**KNOXVILLE HISTORIC ZONING COMMISSION  
STAFF REPORT - CERTIFICATE OF APPROPRIATENESS APPLICATION**

**PROPERTY ADDRESS:** 801 Eleanor St 37917

**FILE NO.:** 6-A-15-HZ

**DISTRICT:** Fourth and Gill H-1

**DETAILS**

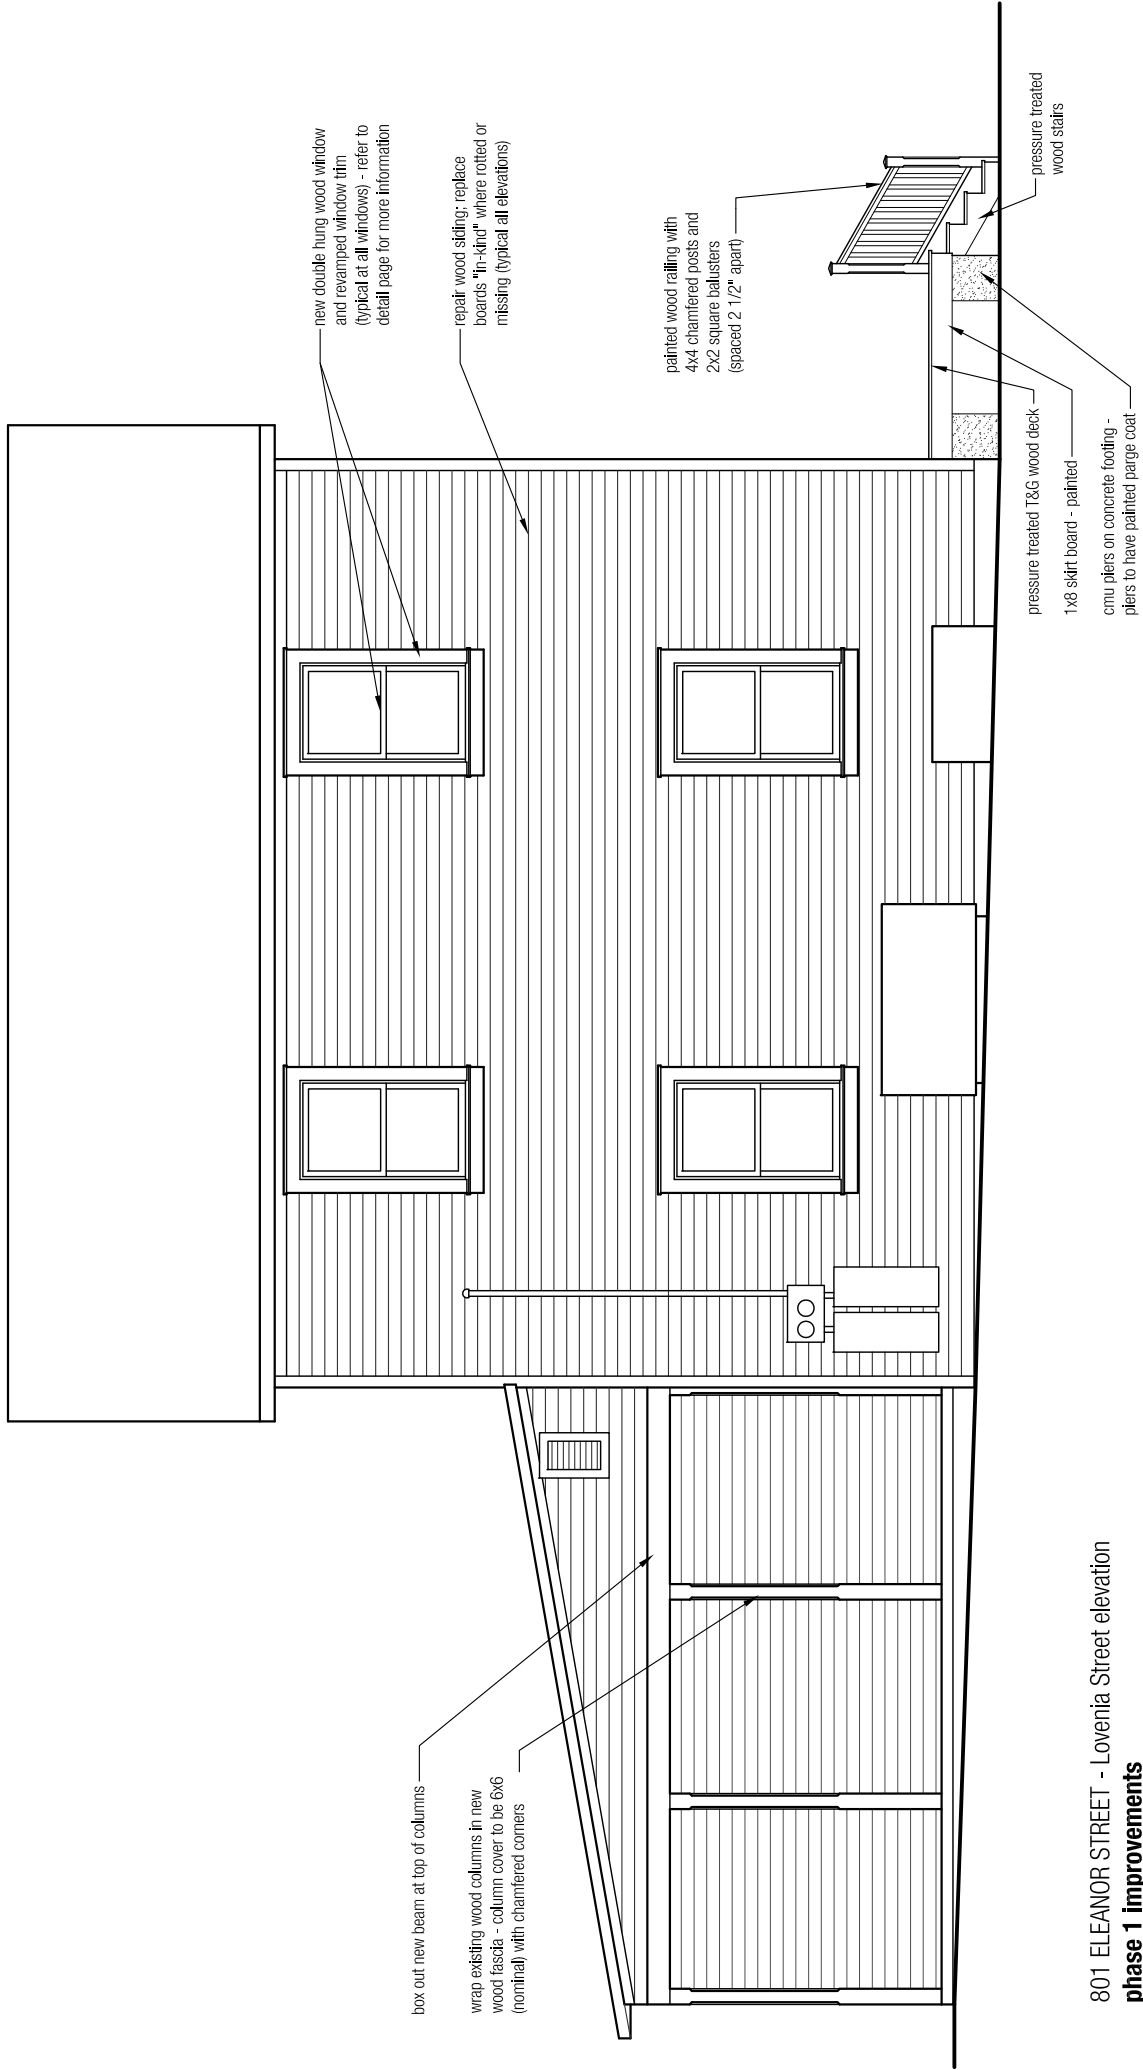
6. The existing windows are not original. The proposed window casing trim would add appropriate historical detail to the windows. Wood double-hung windows are an appropriate window-type for the house.

801 ELEANOR STREET - Eleanor Street elevation  
**phase 1 improvements**

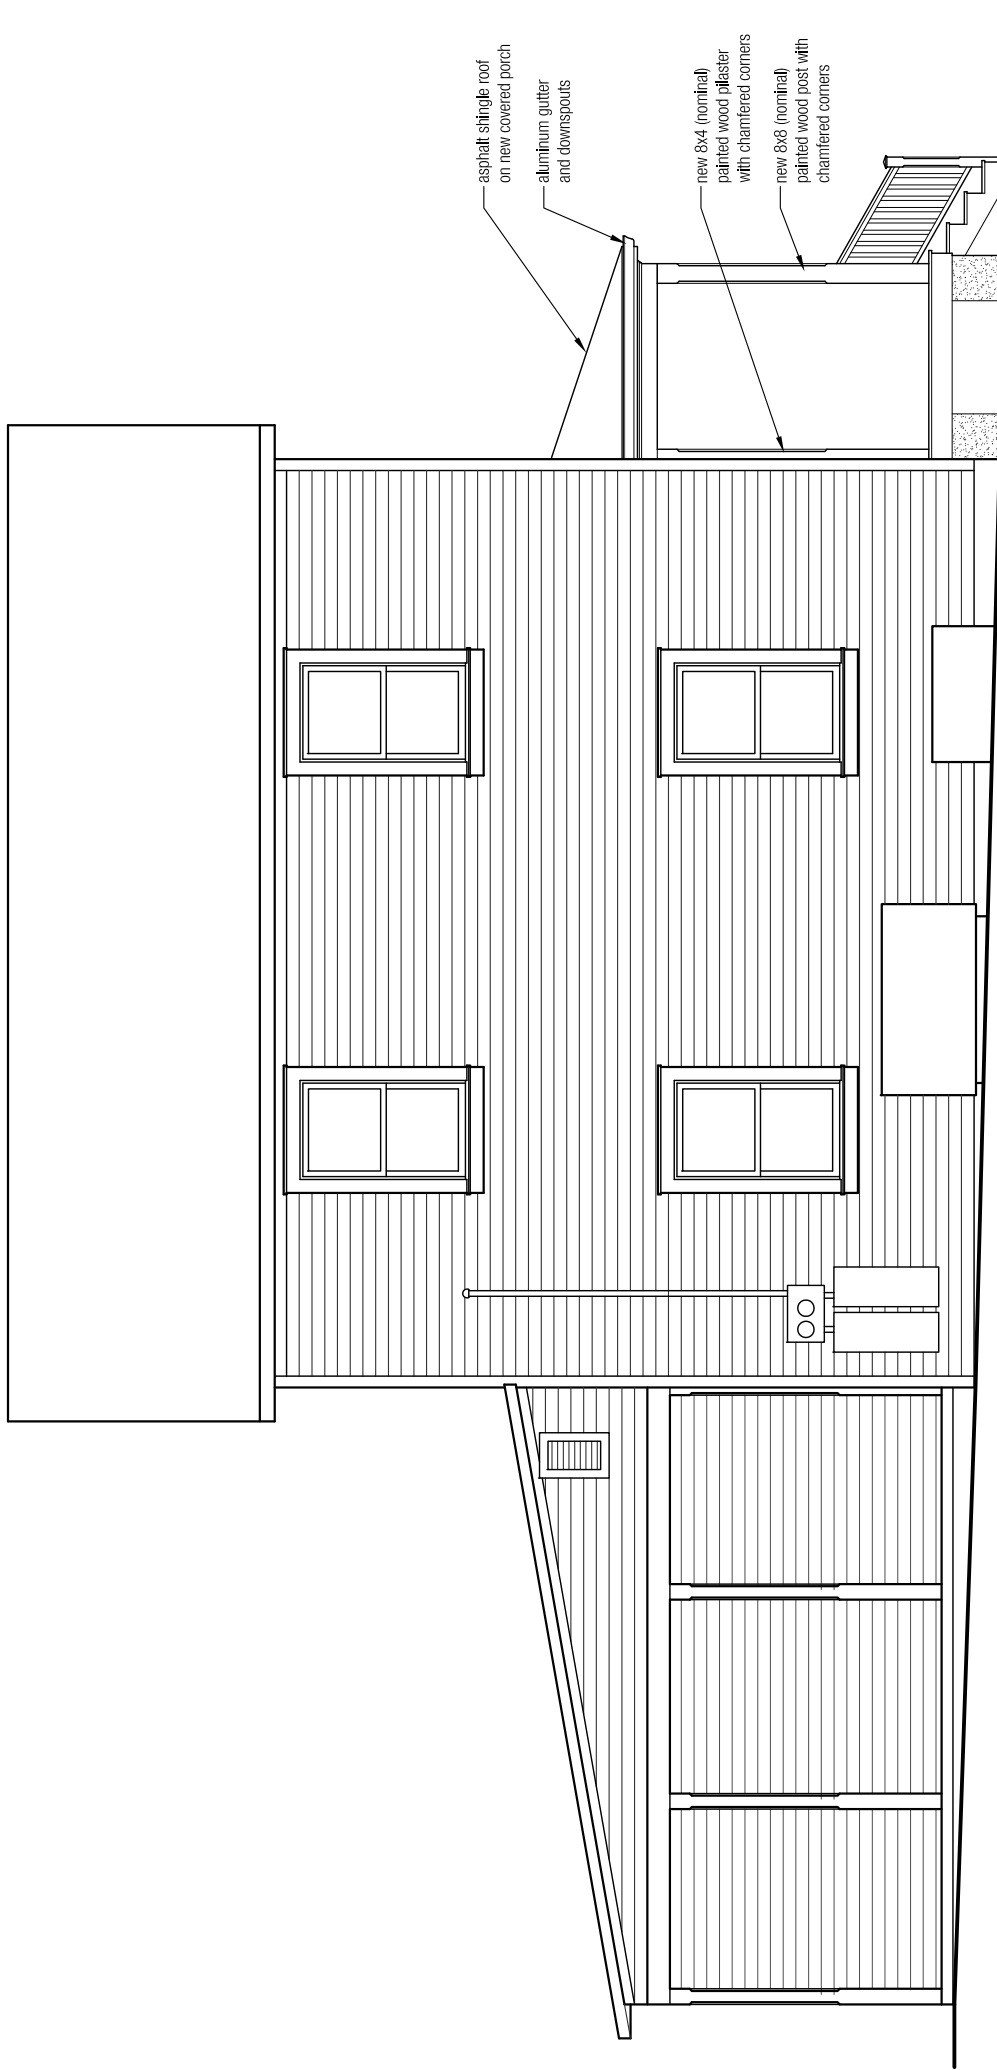
3. The proposed wood railings at the porch stair are not connected to the house or a porch balustrade in the Phase I proposal, and therefore have a "floating appearance."

4. A simple wrought iron railing at the stairs would have lower profile in the Phase I proposal, and have less of "floating" or disconnected appearance.

Approval of Phases 1 and 2 with conditions of providing underpinning in the form of landscaping or lattice between porch support pilings; simple wrought iron railings at the front porch stair, and a reduction of the 6x6-inch-square rear porch post dimension as much as possible.
